Service Bulletin SB-T-04-1400C-0006

RDR-1400C WEATHER RADAR SYSTEM

**RT-1401B RECEIVER-TRANSMITTERS
P/N 4000831-0105 AND -0106)
Unit Mod 10**

**PRODUCT IMPROVEMENT TO
ADD CAPACITORS TO PREVENT TRANSISTOR OSCILLATION**

Figure 2. Modification Drawing

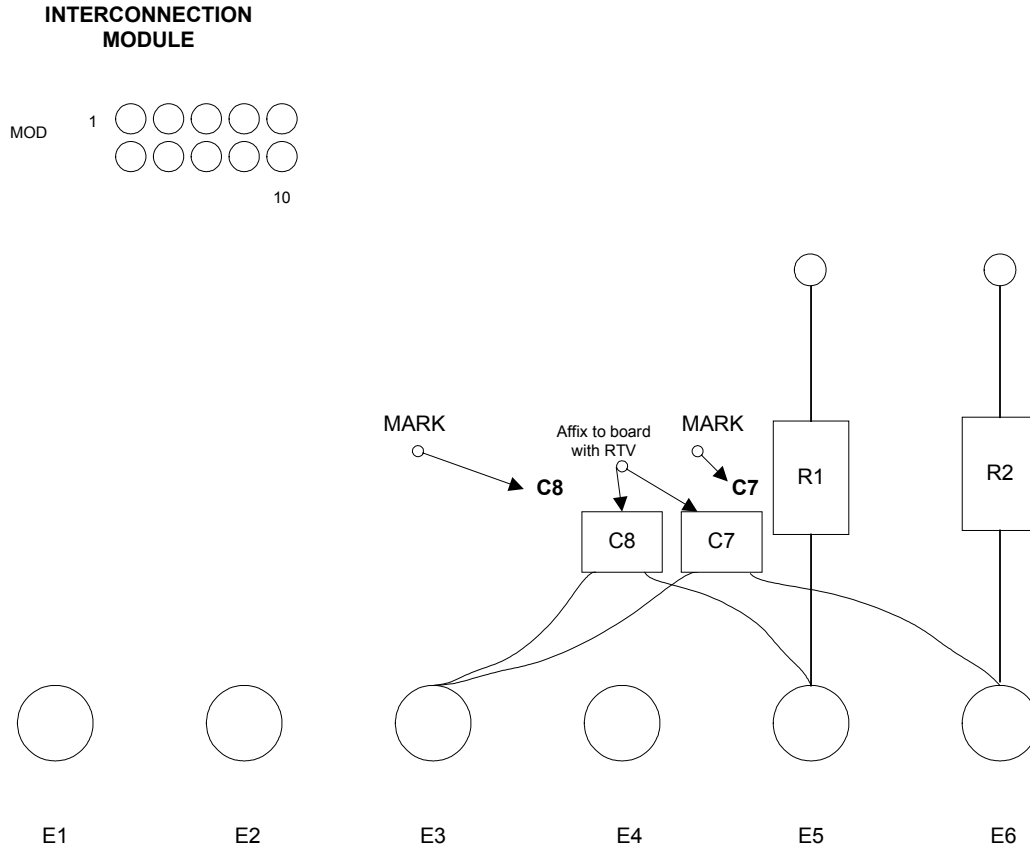
This modification adds 2 capacitors to the Interconnect module.

h. Using Figure 2, locate E1 thru E6 on the Interconnect Module.

- i. Cover capacitors C7 and C8 with sleeving and solder to terminals as shown.
- j. Affix capacitors to board with RTV.
- k. Stamp Reference Designations C7 and C8 with black ink as shown.
- l. Apply a dot of red paint to cover mod 1 of the Interconnect Module modification area.
- m. Apply a dot of red paint to cover mod 10 of the Unit modification decal.
- n. Reassemble RT following disassembly steps in reverse order.
- o. Test unit in accordance with the referenced technical manual.
